Appendix D - Landscape character and visual impact assessment addendum

MRI 82 - BRIDGE STREET, WINDSOR
**REPLACEMENT OF WINDSOR
BRIDGE**
**LANDSCAPE CHARACTER AND
VISUAL IMPACT ASSESSMENT**
ADDENDUM 01

APRIL 2013

Figure 1.1: Proposed changes to the project. The previous design presented in the EIS is shown in red.

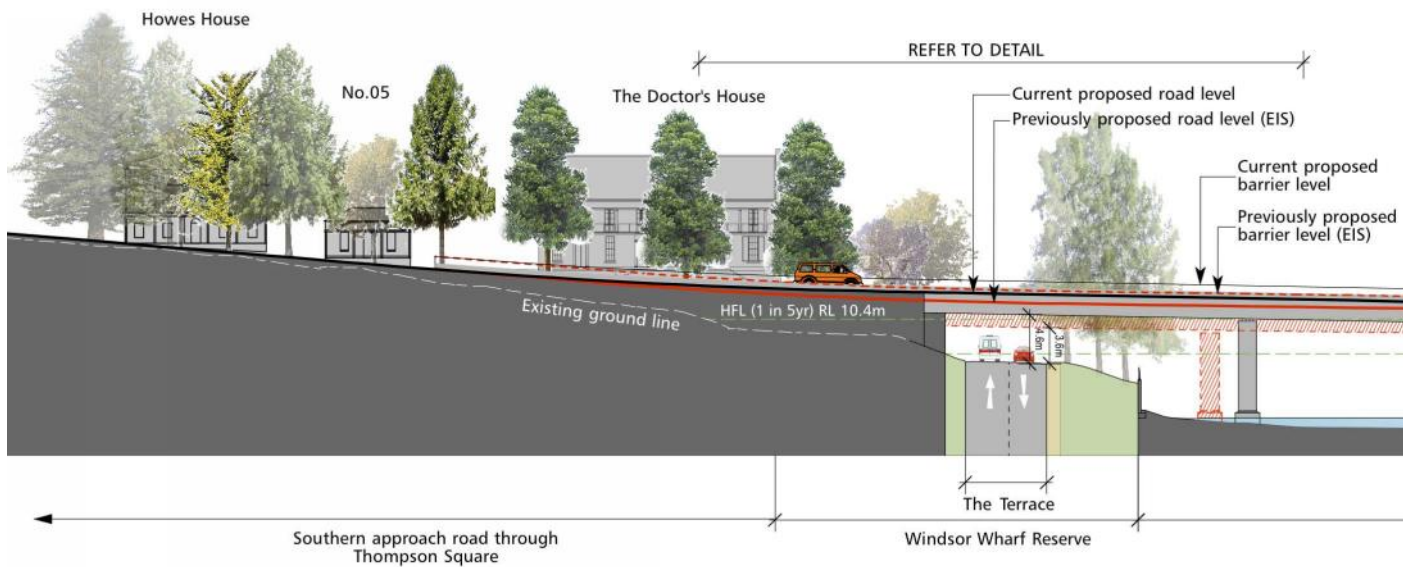
To provide the additional clearance over The Terrace the height of the southern end of the proposed bridge would be increased. This would result in a one metre higher bridge and abutment at the southern end - and a marginally higher 45 metre section of the southern approach road through Thompson Square between the driveway of No. 4 Bridge Street to the southern abutment. South of the driveway of No. 4 Bridge Street and in front of the heritage listed properties of No. 6 and No. 10 Bridge Street, the height of the southern approach road would remain the same as that presented in the EIS. The road level grade of the bridge would also increase slightly from 1.6% to 1.9%.

The location of the piers would be slightly changed so that they are evenly spaced across the river, supporting equal spans of 31.32 metres along the length of the bridge. The proposed location of the piers are also shown in Figure 1.1. No changes to the abutments are proposed.

Relatively minor amendments to the bridge piers are also proposed. The ovoid pier shape would be replaced by an oval shape to allow hydraulic jacks to be positioned on top of the pier columns at periodic times for bearing replacement. The width would be reduced from 3 metres to 2.5 metres to suit the solid girder shape and the requirement to include a restraint corbel on the inside of the girder related to a change in bearing type from pot to laminated elastomeric bearings.

Figure 1.2: Detail section at The Terrace.

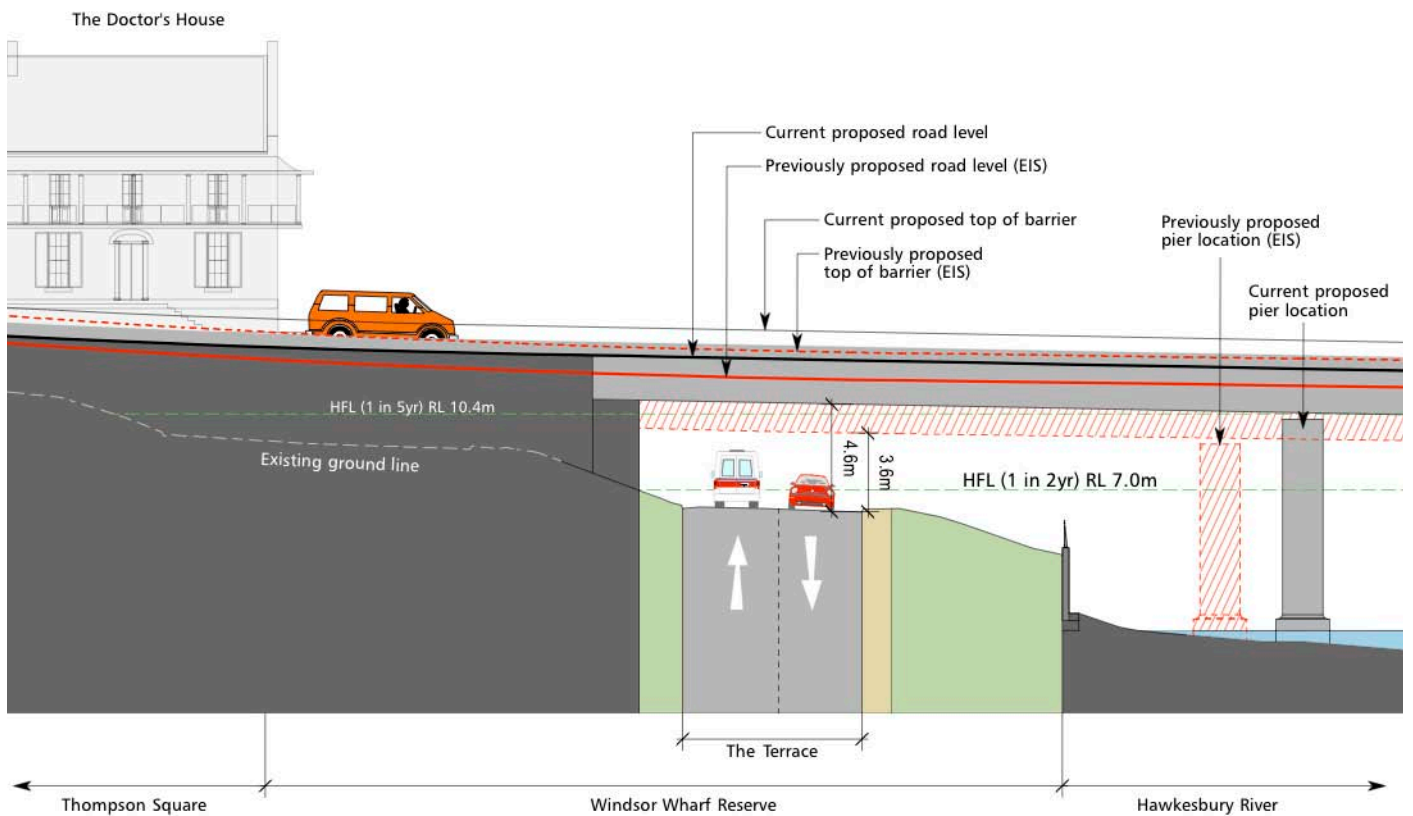
In response to a number of submissions received during the exhibition of the EIS, Roads and Maritime Services (RMS) propose to amend the design to increase the clearance of the new bridge over The Terrace from a minimum of 3.6 metres to a maximum of 4.6 metres to allow large coaches and garbage trucks to directly access Windsor Wharf. Large coach access to Windsor Wharf is required to allow the patrons of the Hawkesbury Paddlewheeler to have easy access to the wharf. Many of the patrons of the Windsor paddle steamer are elderly, disabled and/or have limited mobility and would find it difficult or impossible to access the wharf if existing arrangements were changed and large coaches were restricted to parking in Thompson Square road or Baker Street.

Figure 1.3: Proposed changes to the project in relation to the buildings on Bridge Street.

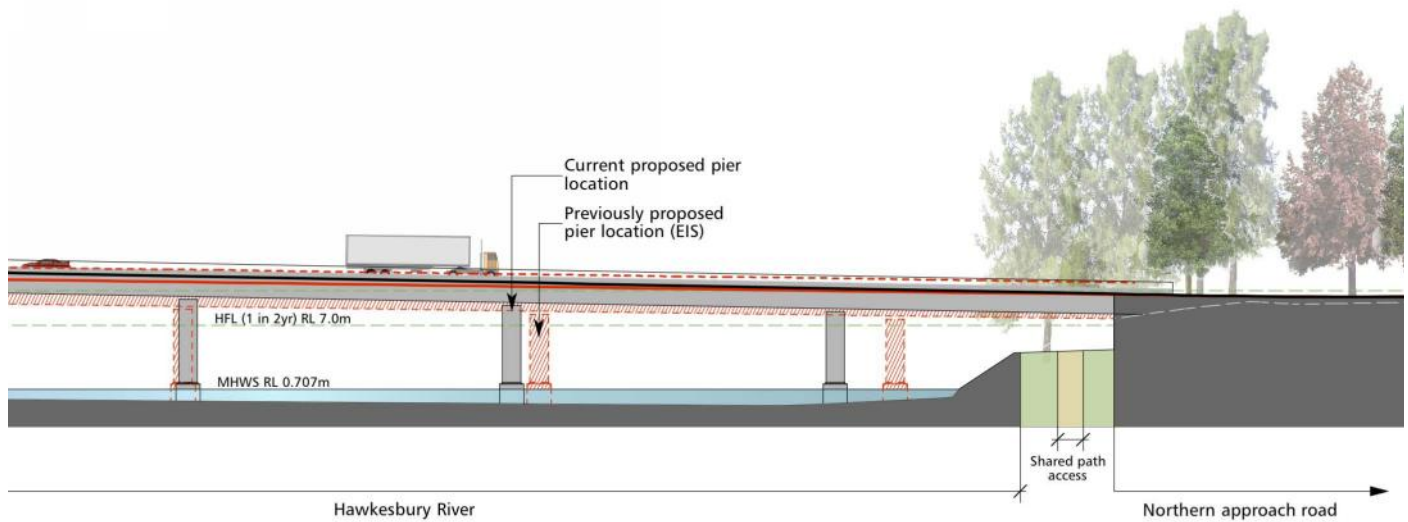
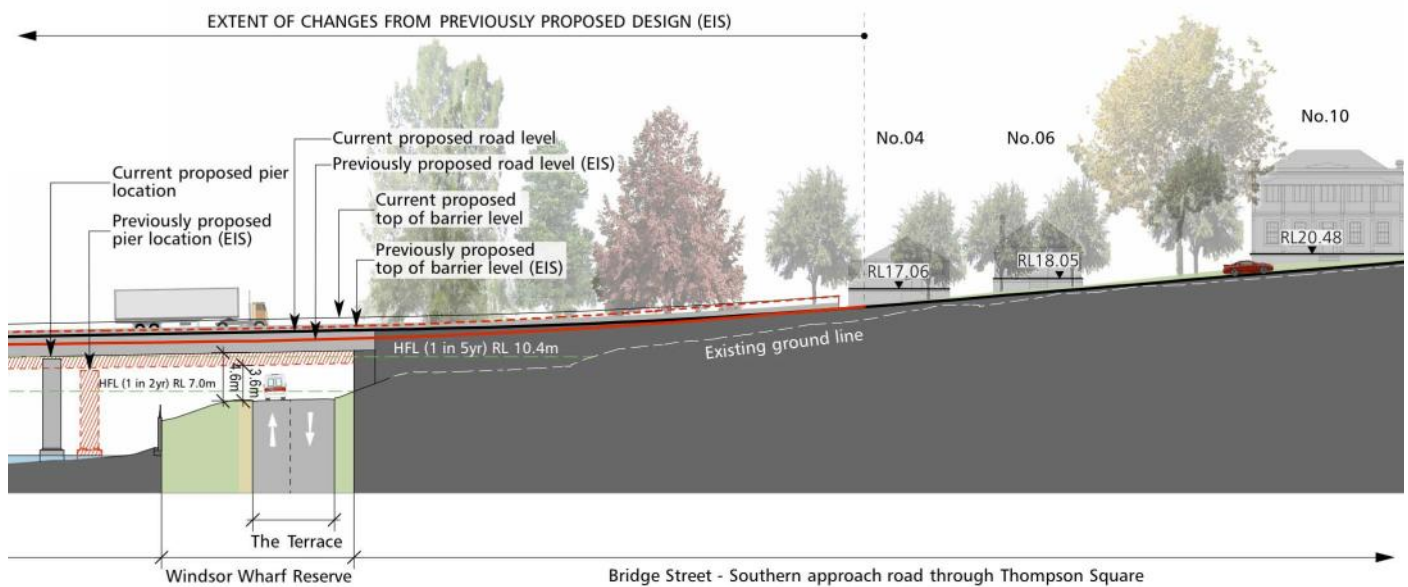
The proposed design changes would add to the vertical scale of the bridge abutments, slightly increasing its physical and visual presence within Thompson Square and when viewed from the buildings along Thompson Square road.

The physical and visual dominance of the proposal, as reported in the EIS, including the proposed southern approach road to the proposed bridge through Thompson Square and the bridge abutments, would now be marginally higher; slightly increasing their presence on the lower section of Thompson Square. A slightly higher underside to the bridge deck at The Terrace, would slightly improve the spatial experience of the roadway with slightly increased headroom and therefore slightly increased amounts of natural light.

Figure 1.6: Shadow cast by the replacement bridge on 21st June.

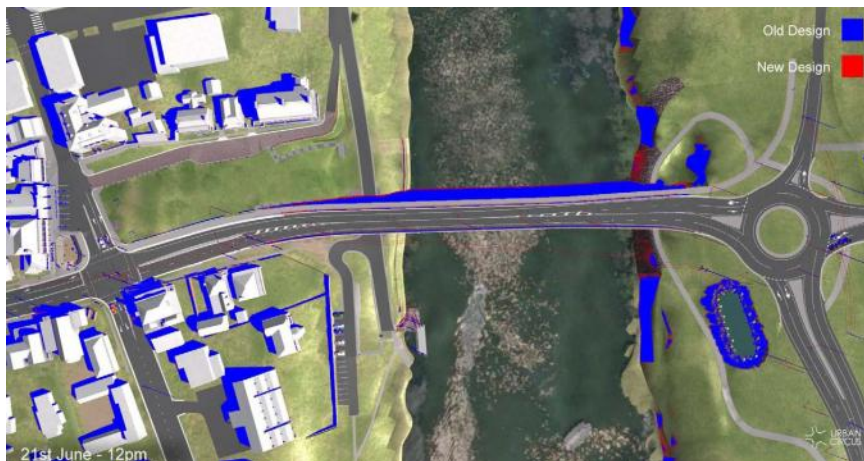
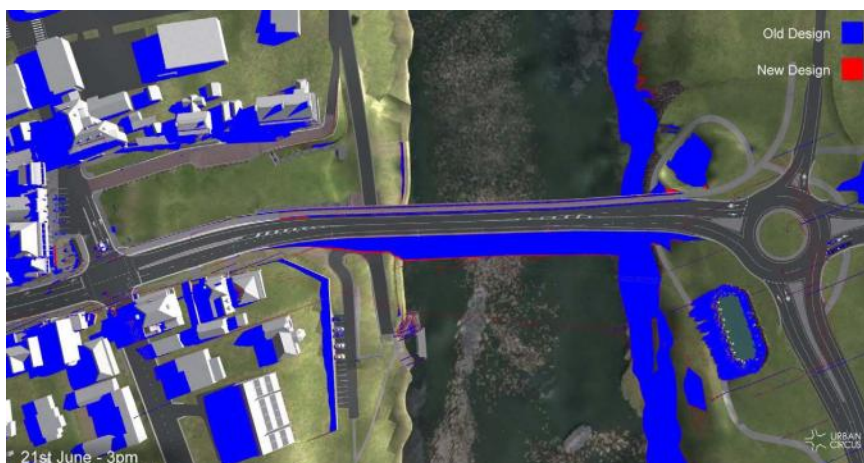
Additional shadow diagrams have been prepared by Urban Circus (Figures 1.5 and 1.6), using a computer model of the study area and incorporating the changes to the Concept Design. They show the shadows of the design presented in the EIS in blue, and the shadows of the proposed changes indicated in red. The diagrams depict the shadows cast by the bridge during the winter solstice (21 June) and the summer solstice (21 December) at three times of day; 9am, 12pm and 3pm.

The changes to the design would not greatly add to the existing overshadowing effects of the bridge. Generally, the shadow extent would remain similar; its footprint would move south. The most noticeable change would be in the early morning in winter to the lower section of Thompson Square, where the approach road on the alignment of Old Bridge Street becomes elevated on a fill embankment as it approaches the abutment, the river foreshore and the river itself. The section of The Terrace directly beneath the replacement bridge would receive slightly more sunlight due to the increased height of the bridge and the location of the piers further away from the foreshore.

The additional overshadowing caused by the increase in height of the southern approach road embankment and bridge would only slightly further affect user's experiences within the lower section of Thompson Square, and would continue to be unlikely to impact on activities occurring on the river.
